Community Development Department
Plan Commission Staff Report
February 16, 2012

Agenda Item F.2.	**Appanasha Pet Clinic, 1205 Wittmann Drive, Parcel 6-01647-00**
Applicant:	Appanasha Pet Clinic
Requested action:	Site Plan Approval
Proposed:	Construction of Veterinary Clinic
Location:	1205 Wittmann Drive
Existing Zoning:	C-4 Business Park District
Surrounding Zoning:	C-4 Business Park District (North, West & East), R-4 Multi-Family Residential (South)
Existing Land Use:	Vacant

Proposed Site Plan

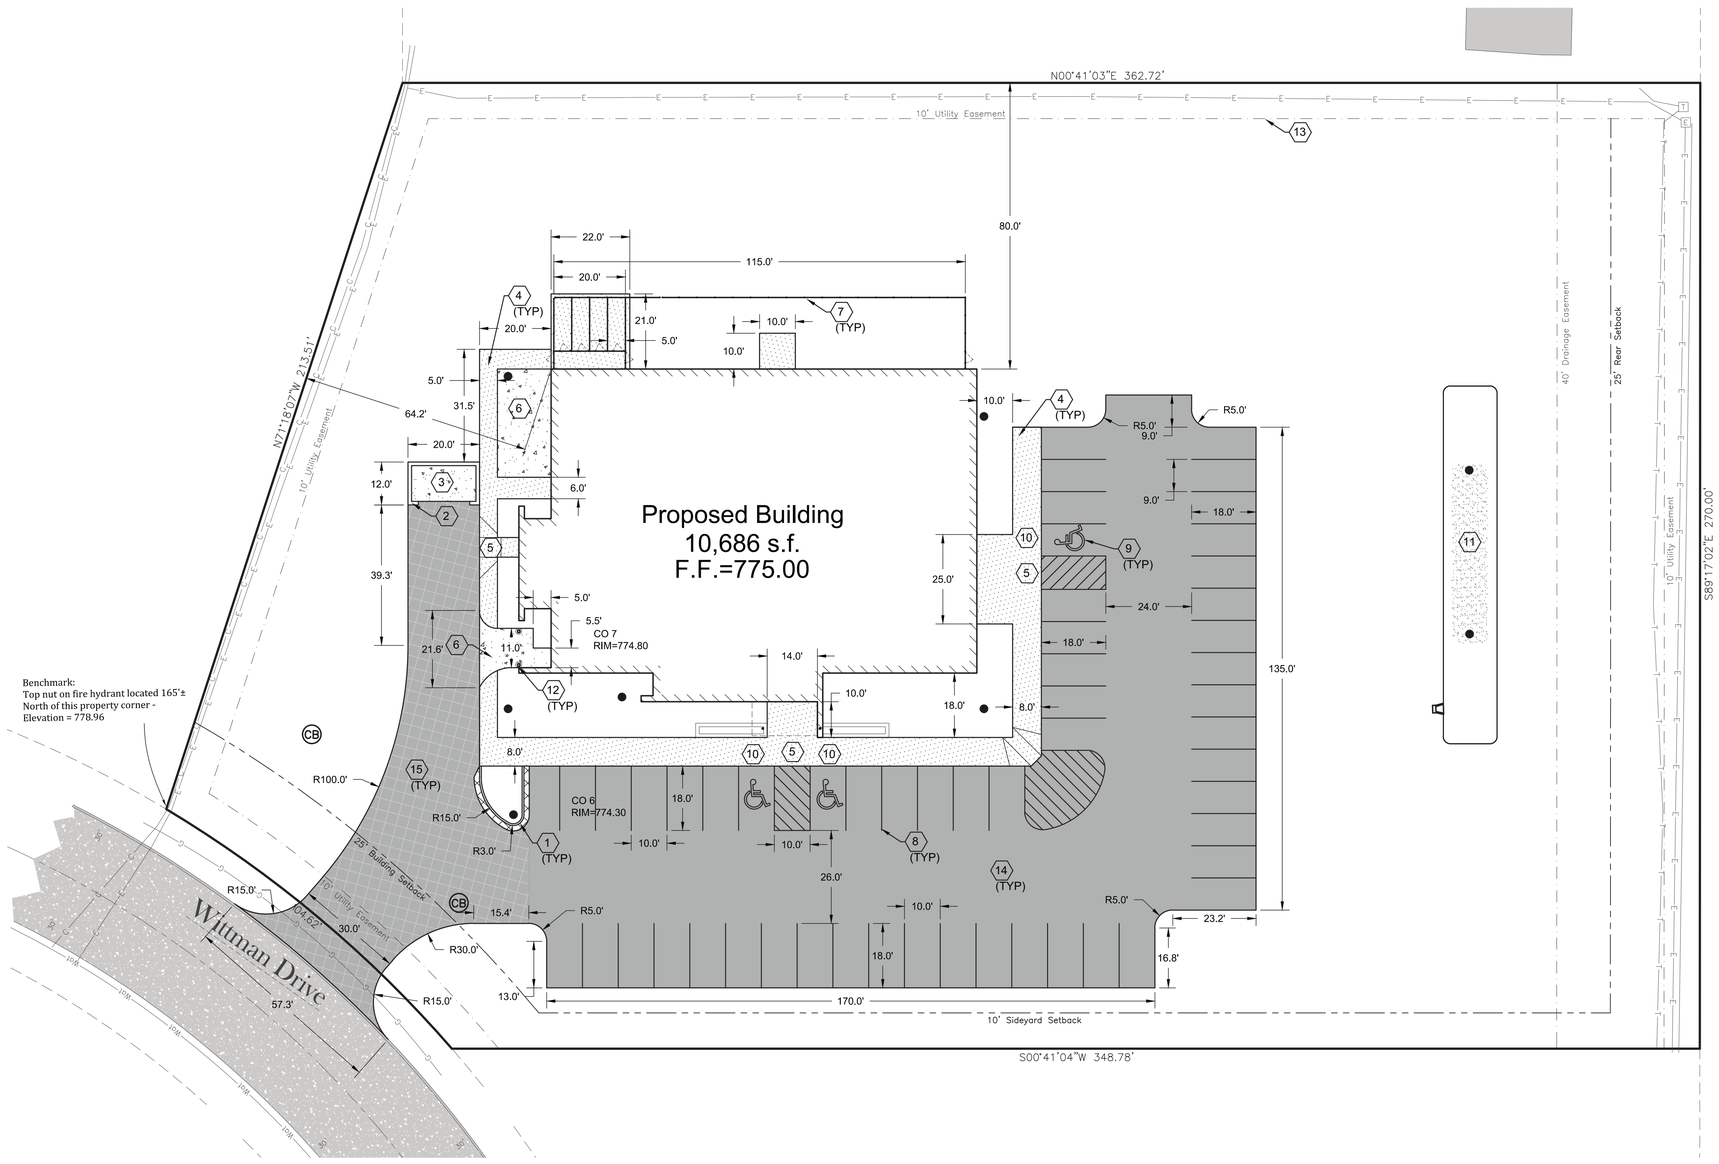
__ employees, for a total of __stalls (being verified with developer). The site plan contains 54 parking stalls, 3 of which are handicap accessible.

LANDSCAPE PLAN

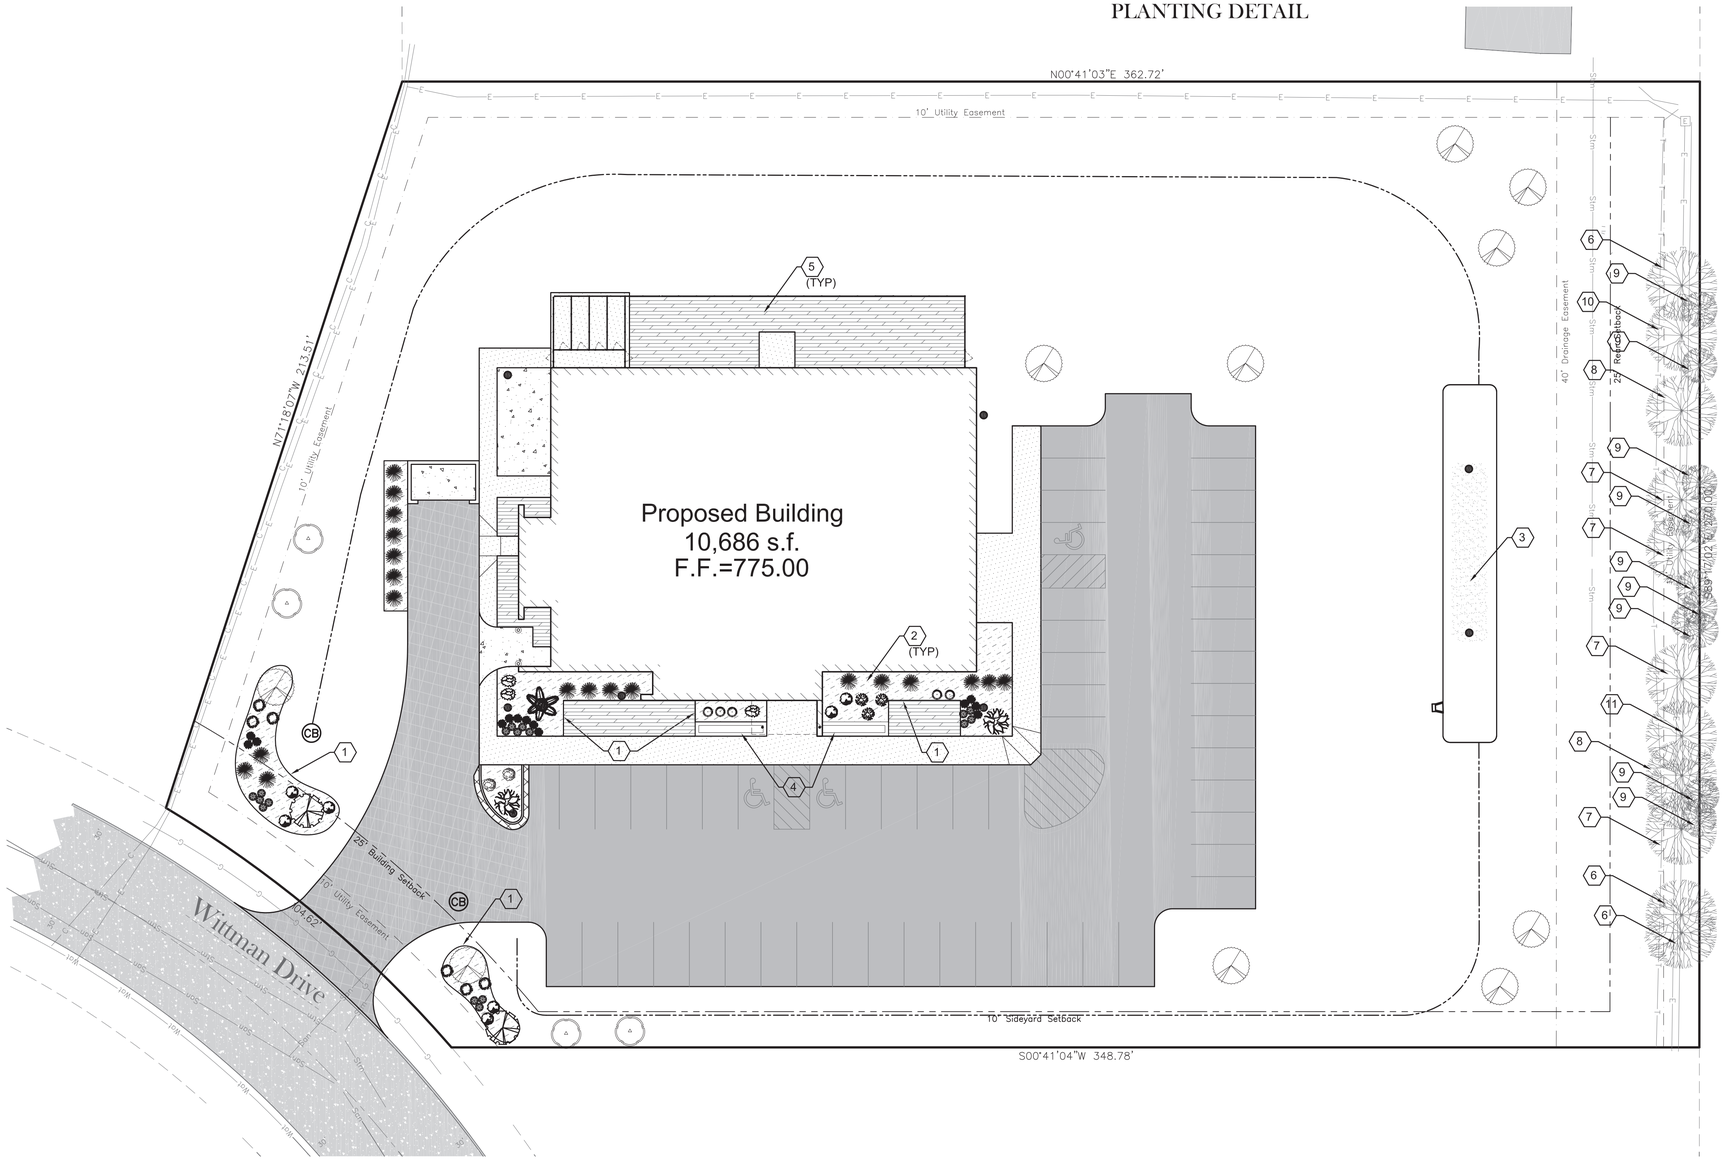
The minimum landscaping requirement for the C-4 District is 20 percent of the site area. Approximately one-third of the site is comprised of building and parking. Additional landscaping is needed in the parking lot interior and along the building perimeter on the north side of the building. There is no specification given for the vegetative cover of portions of the site that are not part of the building footprint, parking lot or landscape beds. The existing vegetation should remain as-is within the drainage easement unless advised otherwise by the Public Works Department (portions of the transitional area planting may extend into the drainage easement, but should not encroach upon the ditch profile).

Transitional landscaping is required, as the proposed commercial use abuts a R-4 multifamily use to the south. Use of existing vegetation is proposed to meet part of the transitional area requirements. The existing vegetation was reviewed by Community Development staff and the City Forester. Much of what is present is comprised of invasive species or otherwise unsuitable plant materials. The specific findings have been forwarded to the site designer and a revised transitional area plan is being prepared.

- The transitional area be revised to comply with ordinance requirements
- The parking lot interior landscaping be revised to meet ordinance requirements and to be submitted to the Community Development Department for review and approval.
- The landscaping plan be revised to include additional building perimeter plantings on the north elevations, and specifications be given for undesignated portions of the site.
- Approval of Stormwater and Erosion Control Plans by Public Works/Engineering staff.

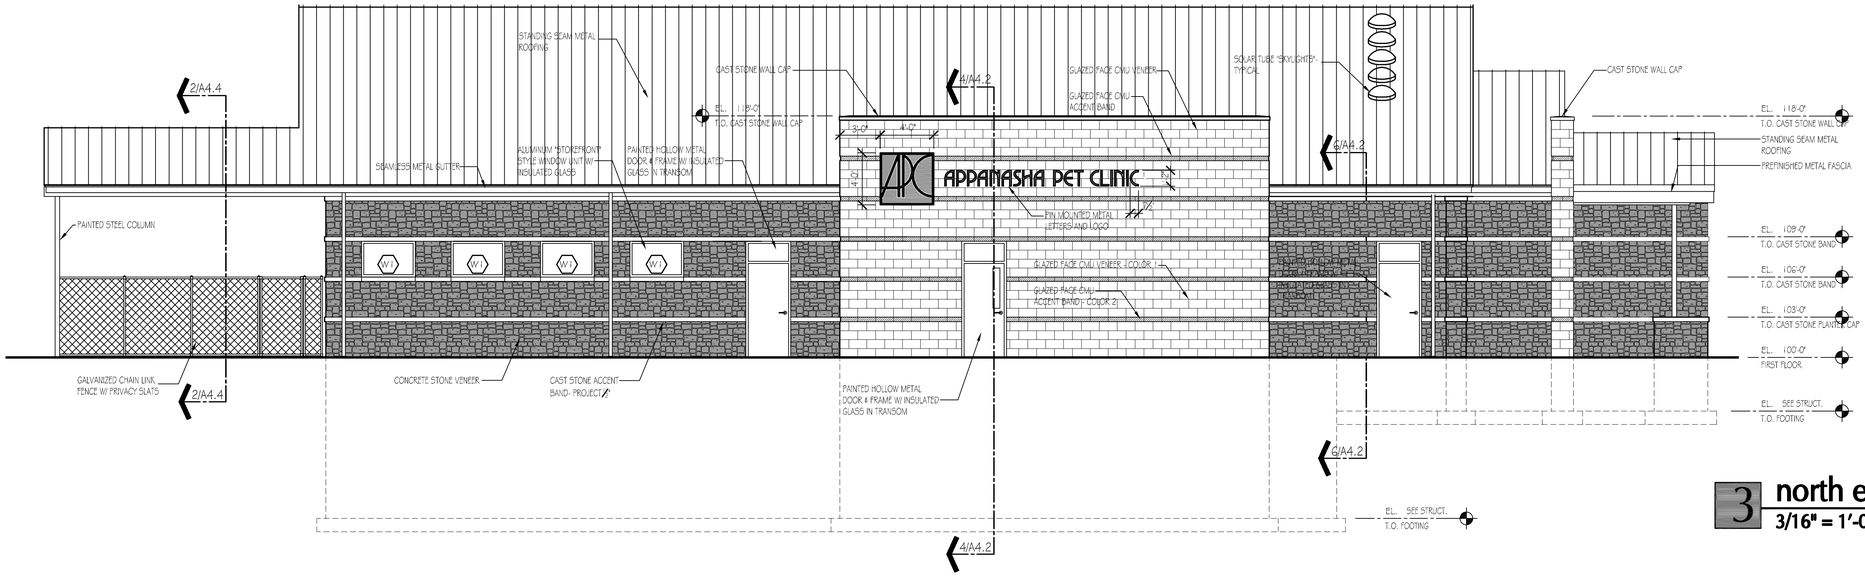
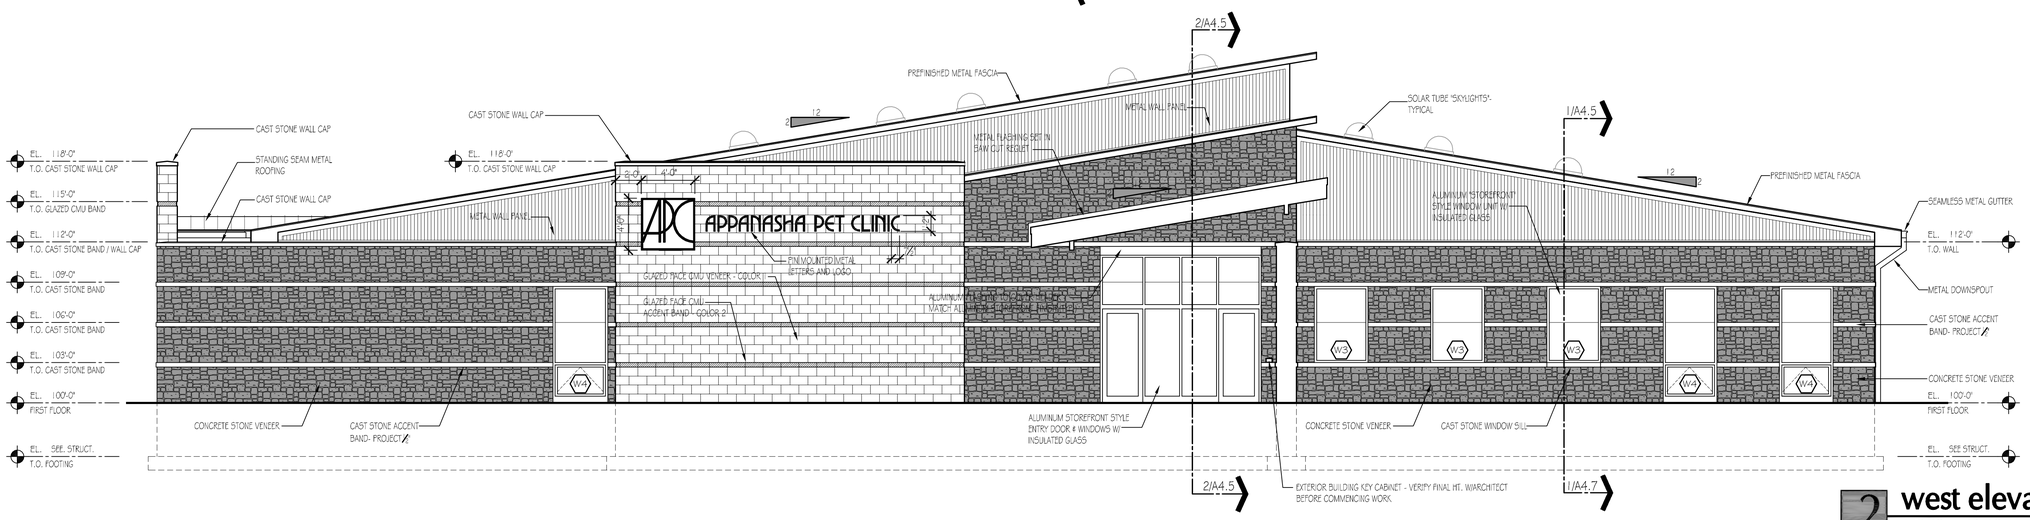
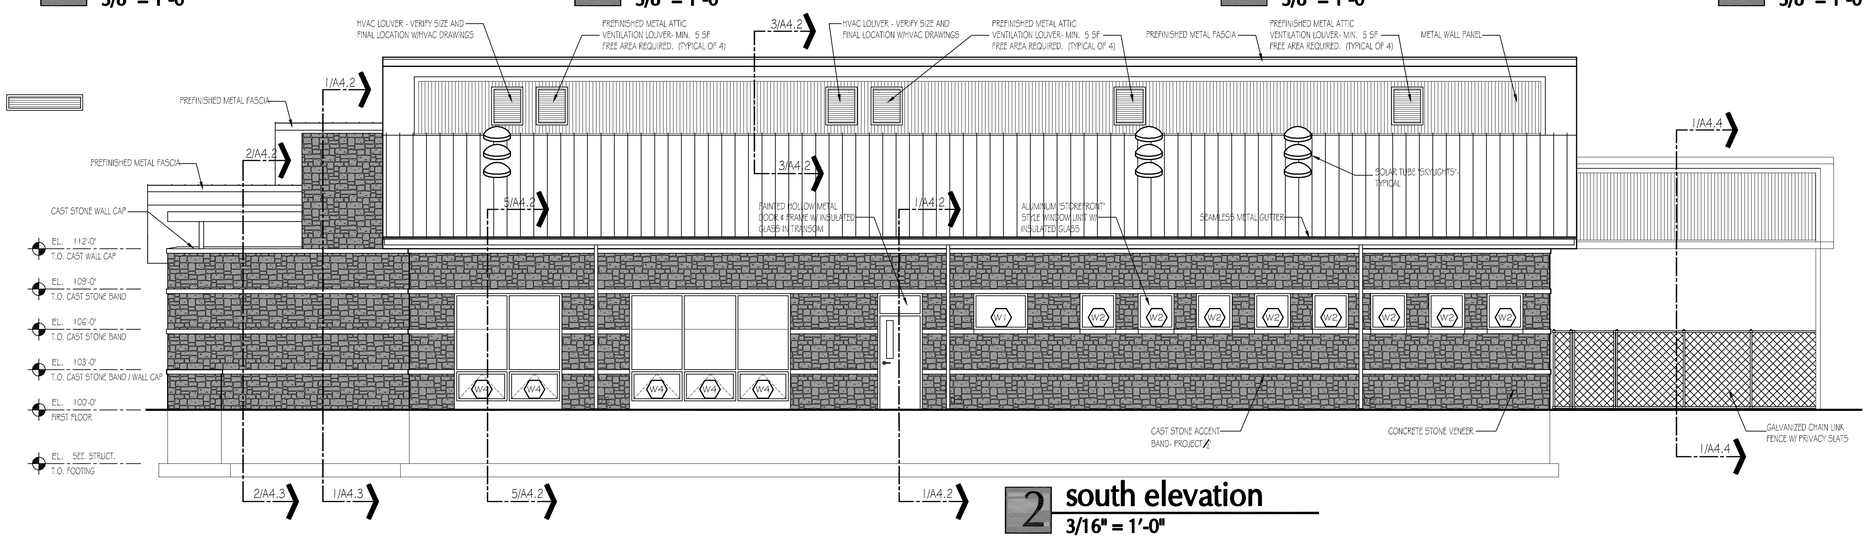
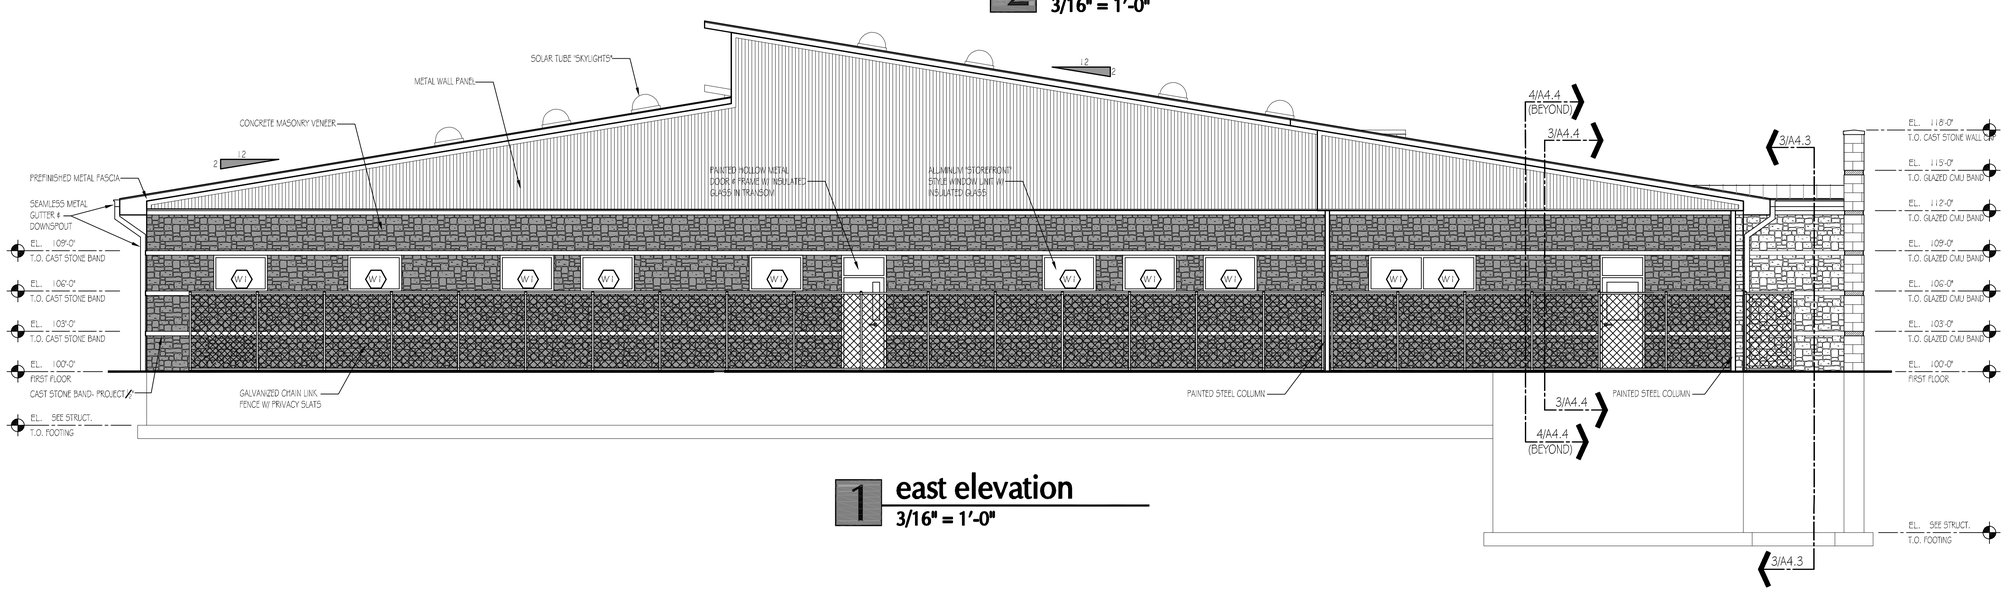
The primary façade materials are comprised of concrete stone veneer and glazed block concrete masonry units with cast stone details. Metals panels are used as secondary façade materials. The overall building architecture provides reasonable articulation in the façade and rooflines. The building elevations meet the 75% requirement for brick, natural stone or decorative masonry units.

Wall signage is proposed for the north and west building elevations. No other signage is proposed for the site at this time.

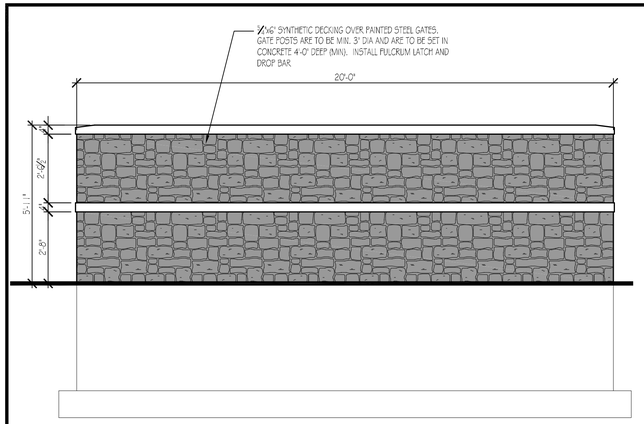
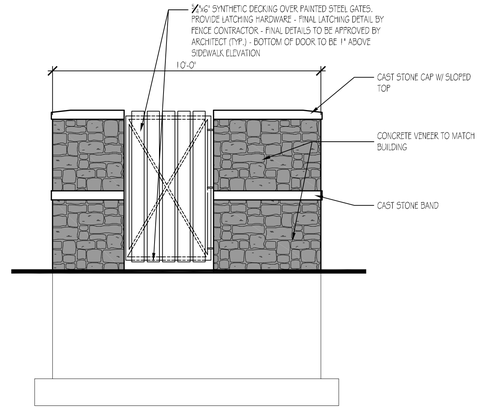
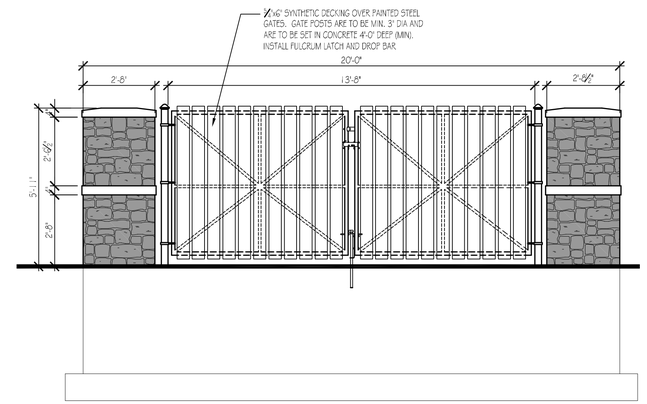
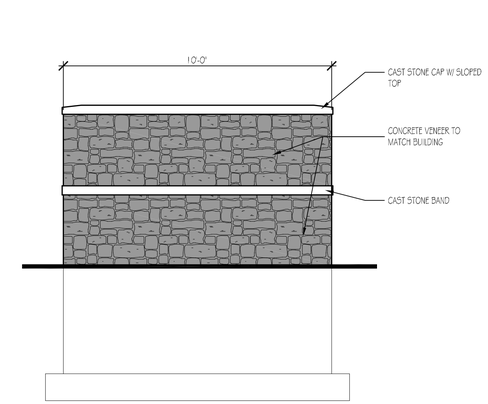
The dumpster enclosure is proposed for the northwest corner of the property, uses materials that match the main building, and will achieve 75% opacity.

1 ELECTRICAL SITE PLAN
1" = 30'-0"

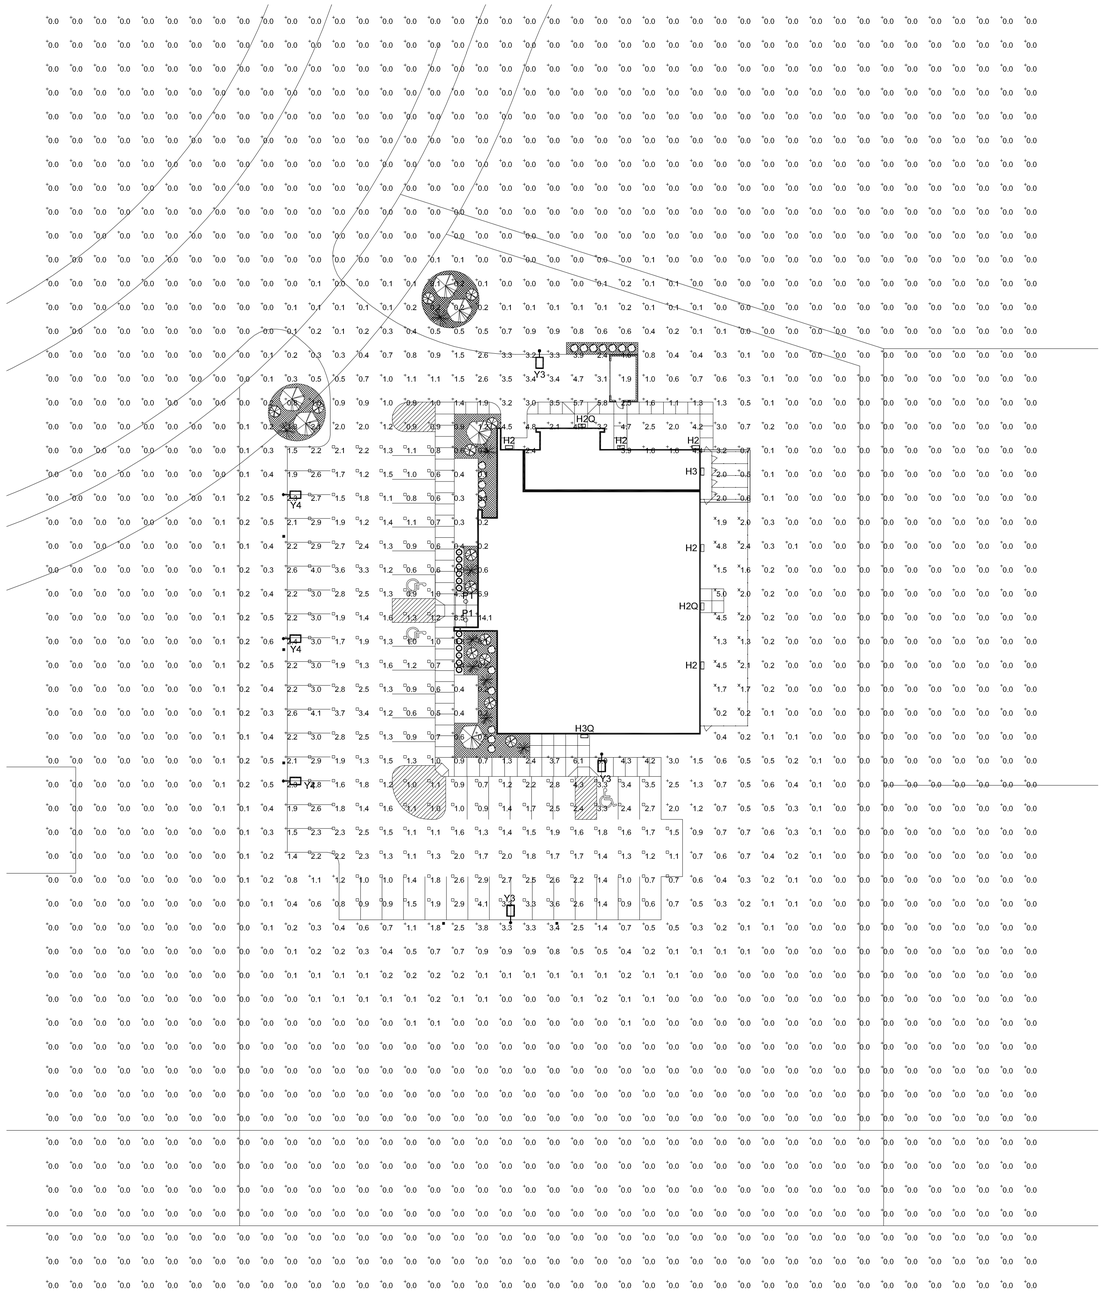
The photometric plan appears to comply with illumination standards.
